KWM-380 TRANSCEIVER (622-5093-001, -101)
HF-380 TRANSCEIVER (622-3580-001, -101)

SERVICE INFORMATION LETTER 3-84

PRODUCT IMPROVEMENT

POWER AMPLIFIER/HEAT SINK ASSEMBLY A1 (634-8481-003)
POWER AMPLIFIER CIRCUIT CARD ASSEMBLY A1A1 (638-6775-001)

CIRCUIT CARD ASSEMBLY A1A1 (638-6775-001)

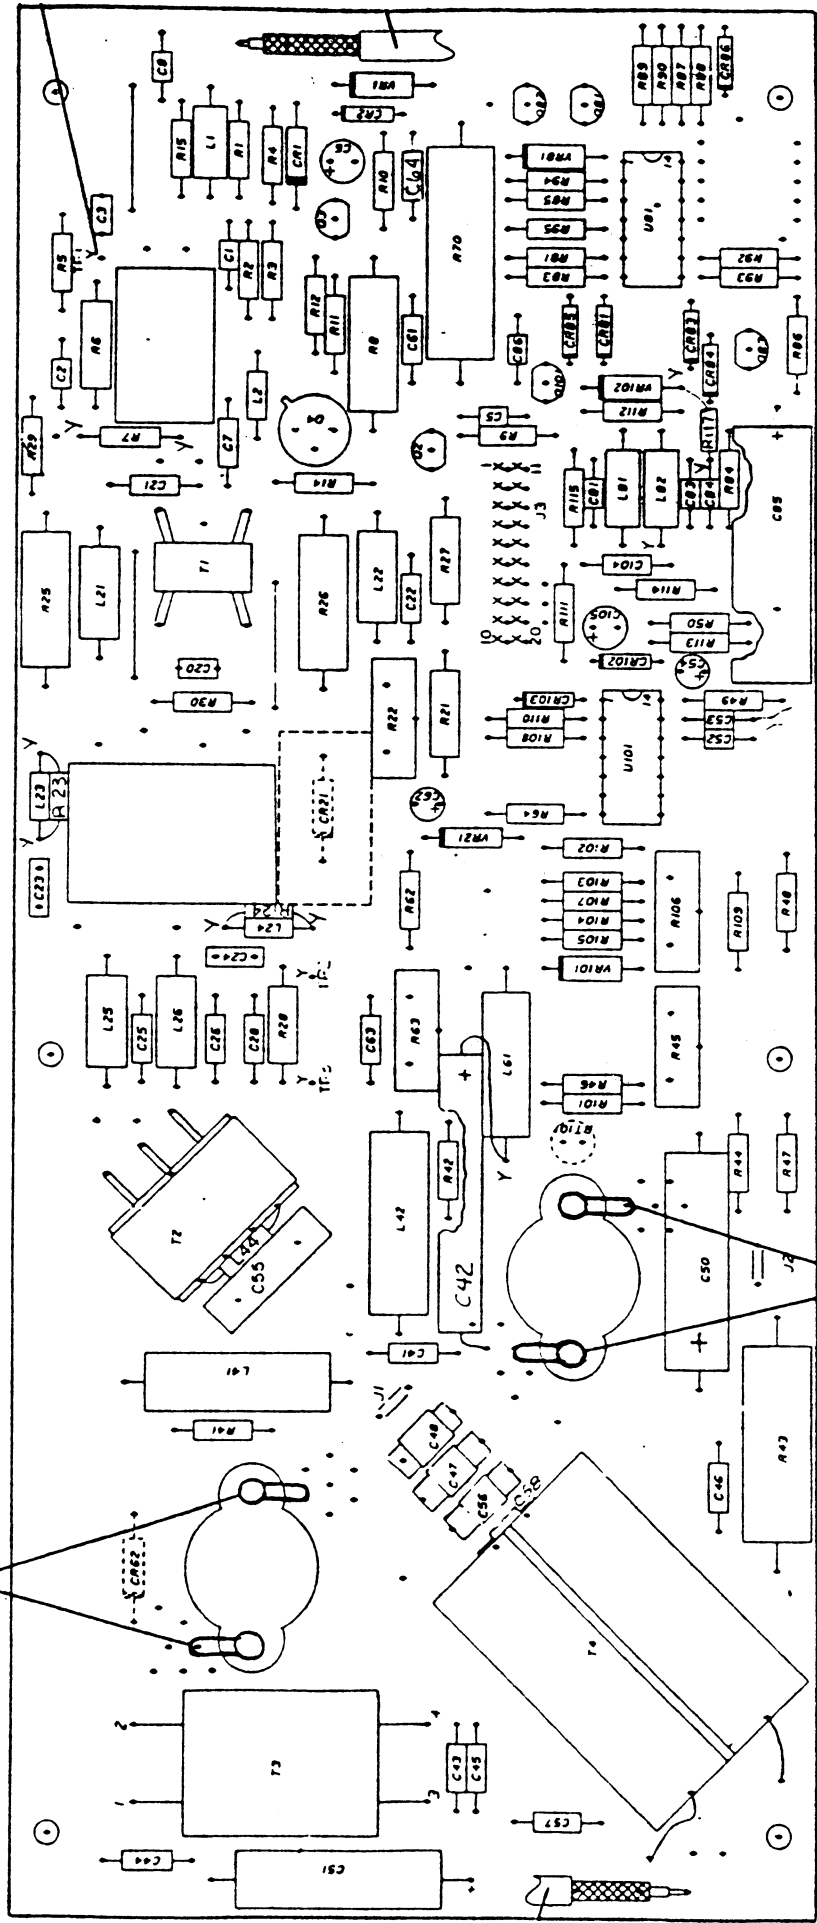
To reduce spurious emissions from the power amplifier.

Complaints of television interference (TVI). Hear interference in another receiver tuned to a frequency distant from the transmitting frequency.

1. Remove the dust cover to gain access to the A1 power amplifier assembly.
2. Remove 3 screws on both ends of the heat sink to allow access for removing shield cover over power amplifier A1A1 circuit board.
3. Loosen the mounting hardware for the output transistors Q41A/B and install 4 small ground lugs (part #304=0332-000), one under each nut. Place lugs as shown in the diagram and solder them to the emitter leads after tightening the hardware.
4. Replace A1A1 board shield cover, remount heat sink, check operation, and then replace dust cover.
